# Public Involvement Meeting Handout

**US 53  
US 63 at Trego  
Washburn County**

Project ID: 1197-00-00

**ID 1197-00-00 | US 53-US 63 Trego Project  
 Alternative 4 from Previously Completed Corridor  
 Preservation Study (2007-2014) (with some minor modifications)**

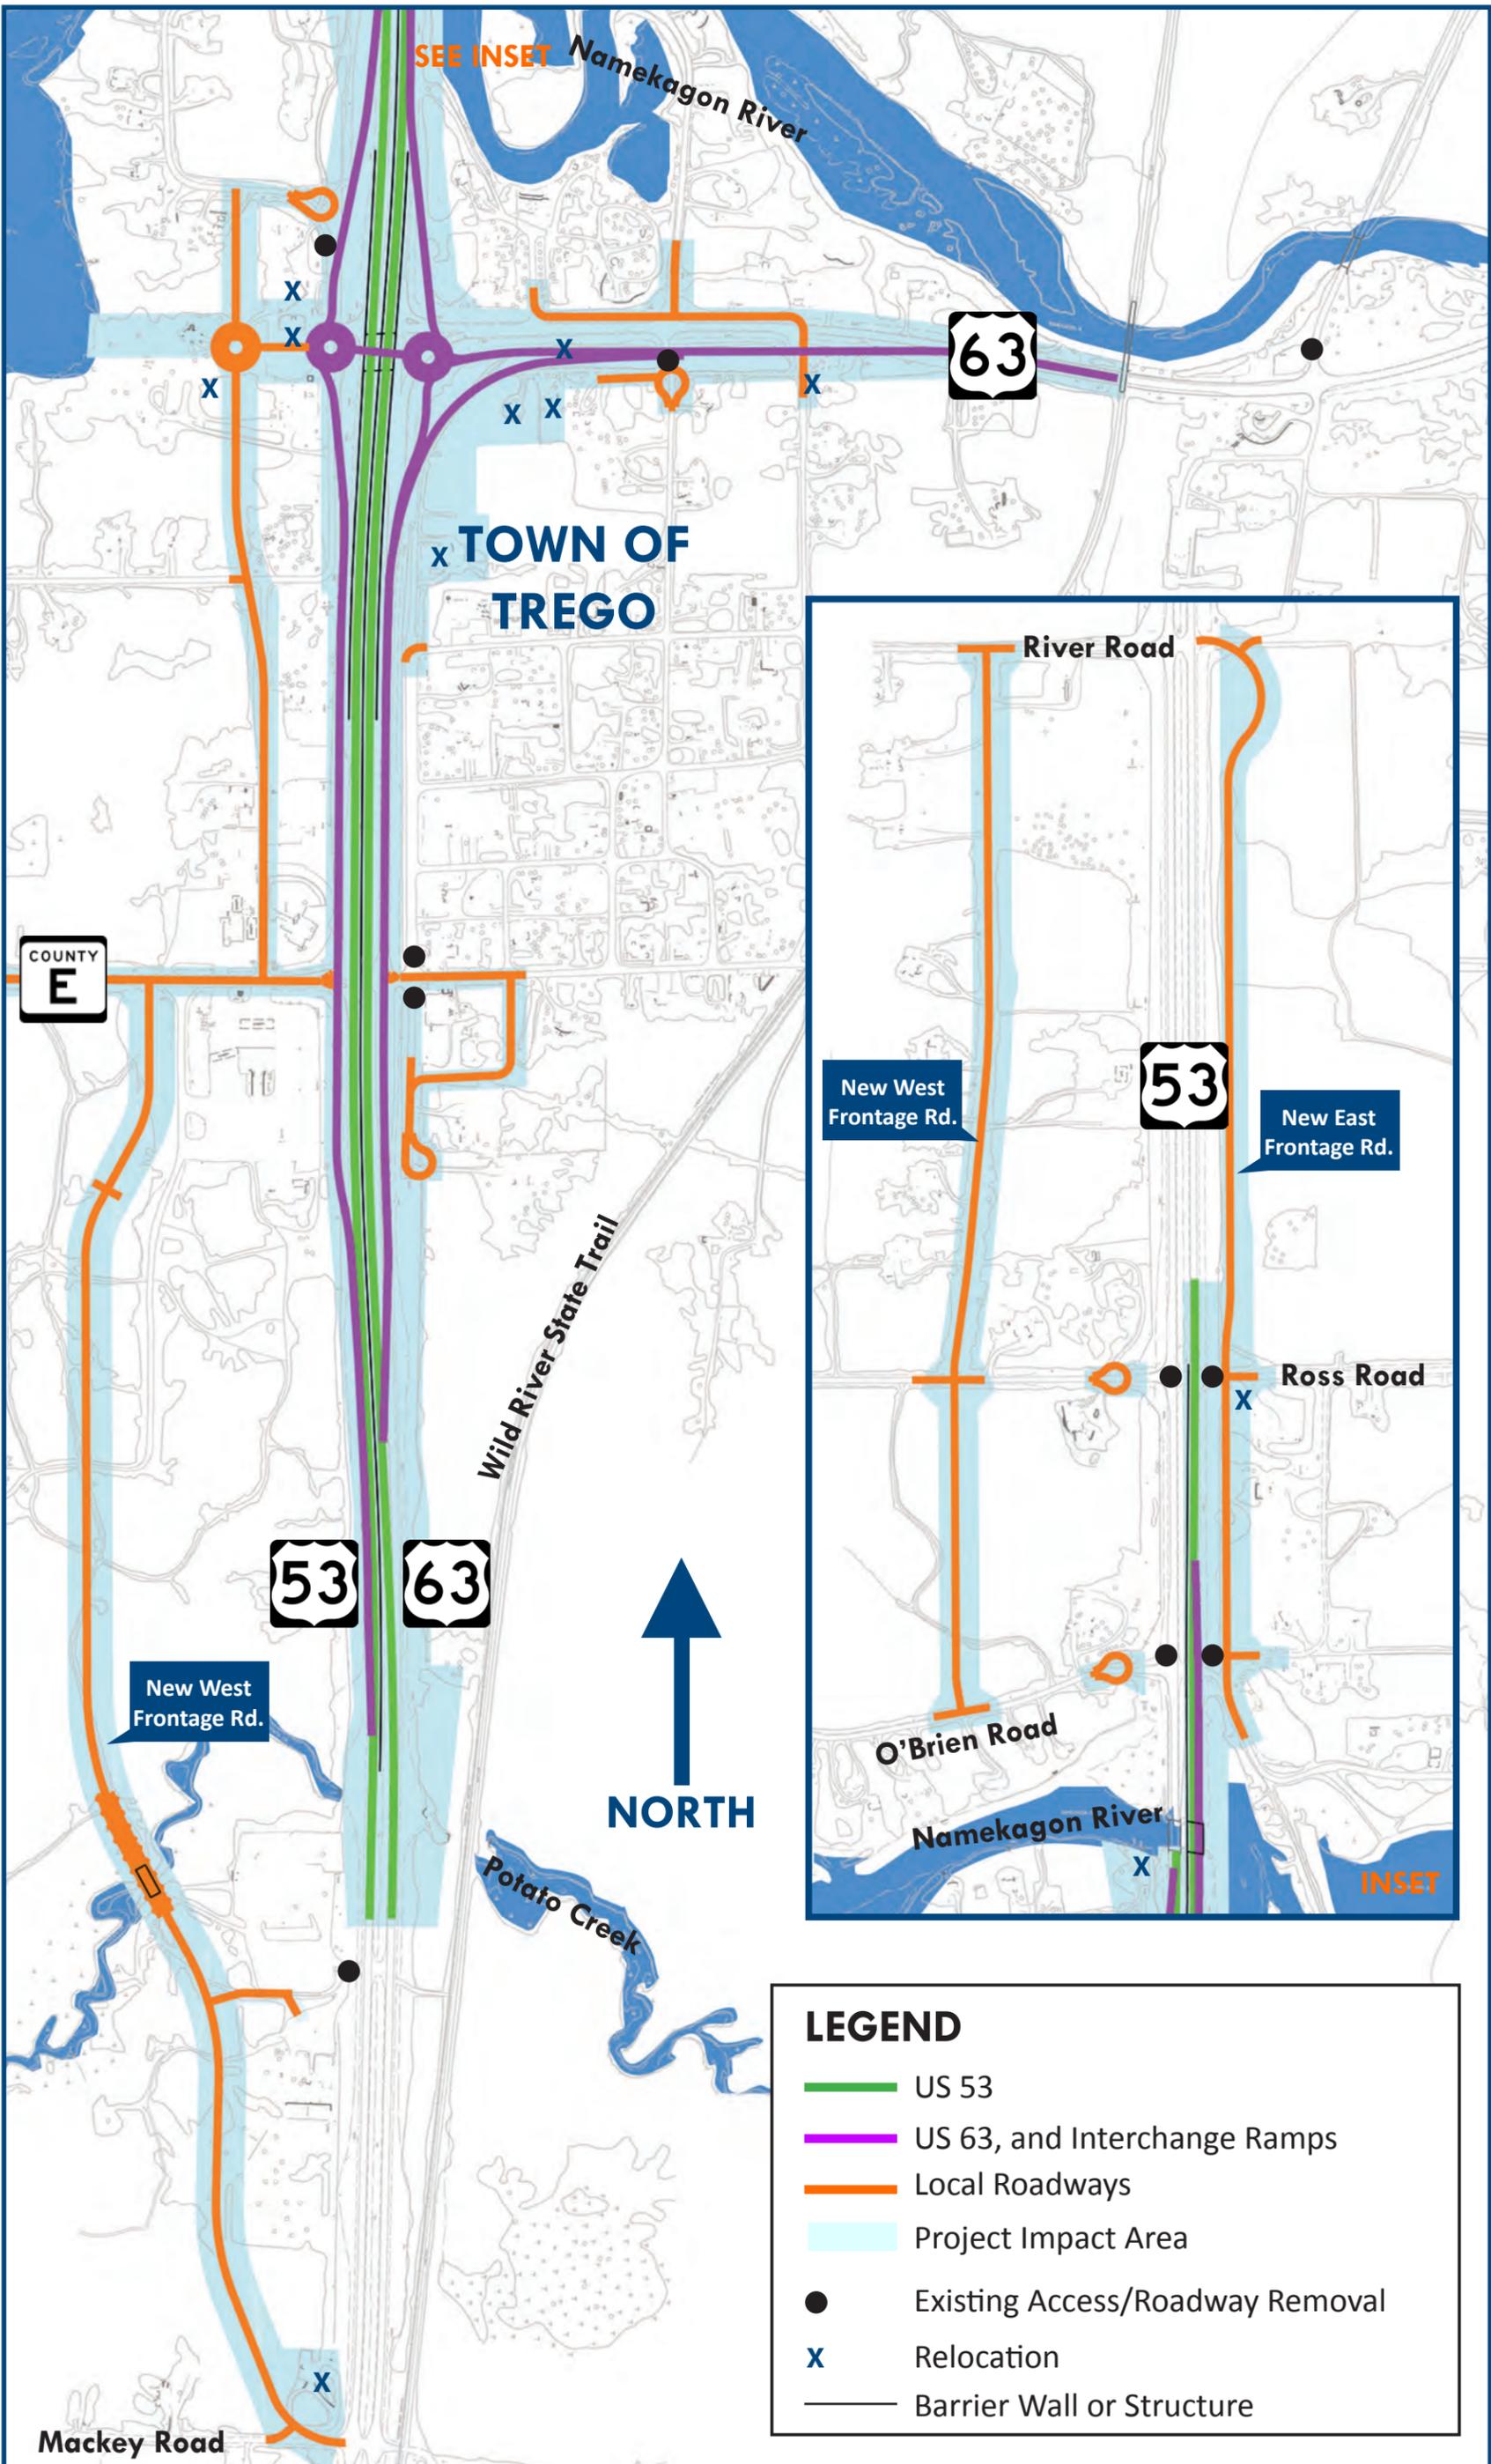
The planning study Alternative 4 does not provide adequate ATV/snowmobile access from the Town of Trego to the Wild River State Trail.

Elimination of at-grade intersections along US 53 in addition to construction of the realigned US 63 divides the Town of Trego into three parts.

Planning study Alternative 4 results in loss of parking at local business.

The proposed West Frontage Road as shown in planning study Alternative 4 has too many curves.

The distance pedestrians would have to walk to cross US 53 via the planning study Alternative 4 interchange is too far.

The planning study Alternative 4 interchange configuration that proposes the realignment of US 63 to the southeast results in lost visibility to area businesses from the highway.

Under planning study Alternative 4, an ATV/snowmobile crossing will be allowed on US 63 near the existing Wild Rivers Trail parking lot to allow access to and from the residential streets of Trego. Additionally, an at-grade crossing will be permitted at the US 53 – Mackey Road intersection to maintain access to the businesses and trails on the west side of US 53.

Under planning study Alternative 4, two alternative intersection configurations have been recently developed that involve constructing the proposed at-grade intersection of a realigned US 63 with Oak Hill Drive as a four-leg intersection. These revised intersection designs provide the desired east-west connectivity within the Town of Trego while maintaining existing access to the Wild River State Trail. Constructing the proposed US 63/Oak Hill Drive intersection as a four-leg intersection would eliminate the proposed East Frontage Road.

Local businesses that are currently using on-street parking can continue to do so after construction is completed as long as the roadway travel lanes are not adversely impacted.

Multiple design refinements have been developed to straighten the roads as much as possible. Several design considerations need to be evaluated before a final decision is made, including intersection spacing, available sight distance, intersection control, and minimizing impacts to private property and/or the environment . Final layout of the roadways will ultimately be a balance of all design considerations.

Under planning study Alternative 4, a grade separated crossing of US 53 via a box culvert/tunnel at the existing US 53/US 63 intersection was evaluated. The existing topography and relative proximity of the Namekagon River pose some challenges with respect to the alignment of the trail connecting Leisch Road with the box culvert entrance as well as stormwater quality and drainage.
